Re: Bus Connects Templeogue/Rathfarnham to City Centre Core Bus Corridor Scheme
Templeogue/Rathfarnham to City Centre

PLANNING SUBMISSION

Submission on the proposed construction of the Templeogue/Rathfarnham to City Centre Core Bus Corridor

TEMPLEOGUE/RATHFARNHAM TO CITY CENTRE - CORE BUS CORRIDOR SCHEME
REVIEW ON BEHALF OF #55, #59, #61, #63, #65, #67 & #71 RATHFARNHAM ROAD:
BASED ON AVAILABLE DESIGN DETAILS AND TOPOGRAPHICAL SURVEY

Figure 1 – Details assumed for the Purposes of this Study

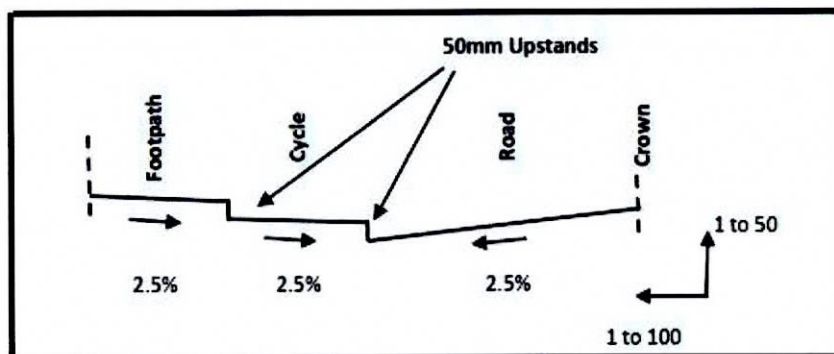
In terms of the impact upon individual residences along the route, given the scant information provided within the statutory documents and the planning application we have had to assume some typical design details (gradients and details which would normally apply to schemes of this nature, with the assumed gradients as illustrated below as **Figure 1**).

Figure 2 – Profile for #55 Rathfarnham Road

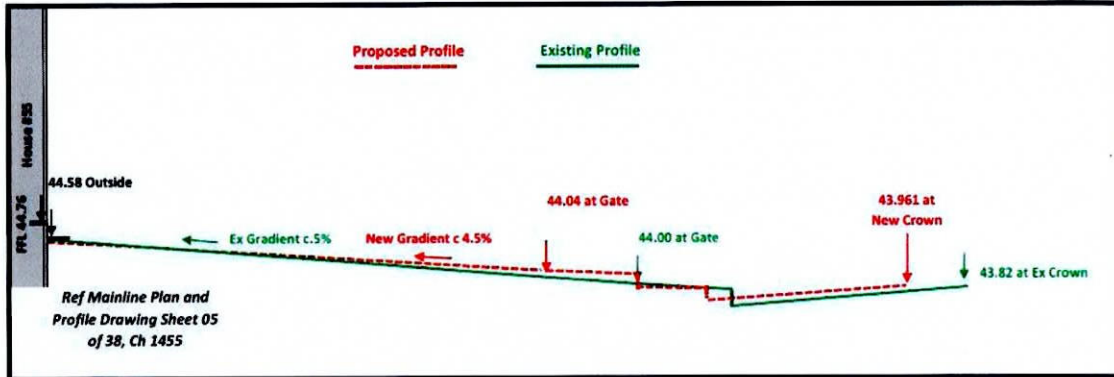
House Details	Current Total Gradient ¹	Future Total Gradient ²	Comment
55 Rathfarnham Rd	5%	4.5%	Improvement
59 Rathfarnham Rd	7.6%	9.6%	Significantly Steeper
61 Rathfarnham Rd	7.6%	8.9%	Significantly Steeper
63 Rathfarnham Rd	6.3%	10.5%	Significantly Steeper
65 Rathfarnham Rd	9.6%	11.1%	Significantly Steeper
67 Rathfarnham Rd	10.6%	13.6%	Significantly Steeper
71 Rathfarnham Rd	8.2%	9.3%	Steeper

Figure 7 – Profile for #71 Rathfarnham Road

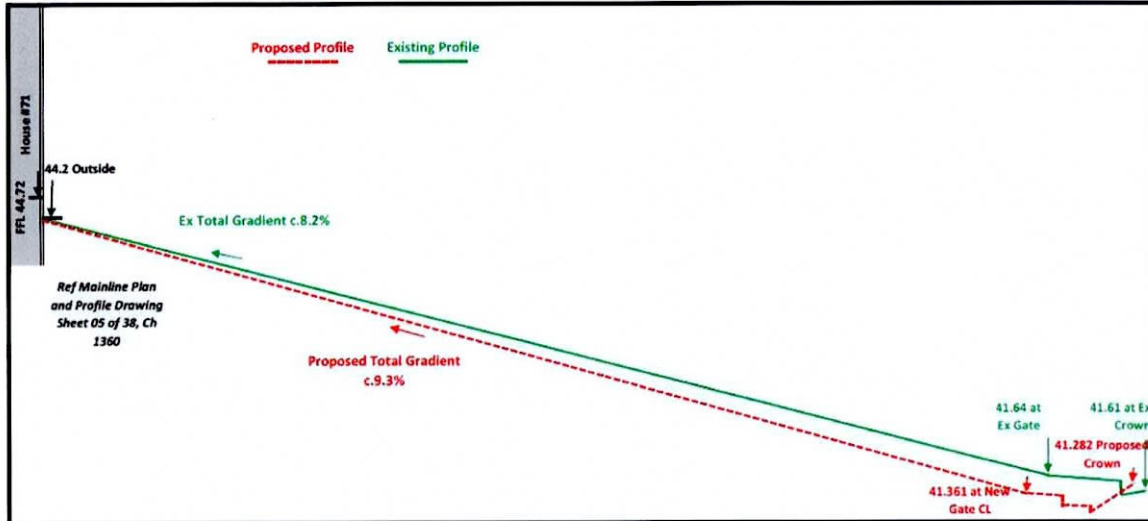
We conclude that the Bus Connect plans (as per the Planning Application, based on the design data provided) appear to result in a significantly steeper approach to the majority of the subject dwellings, clearly contravening National Building Control Regulations.

We would suggest that a comprehensive consequential design for pedestrian and vehicular access from the public road to the door of each house, that meets the Part M requirements, should be provided demonstrating to An Bord Pleanála and each resident that this has been adequately addressed.
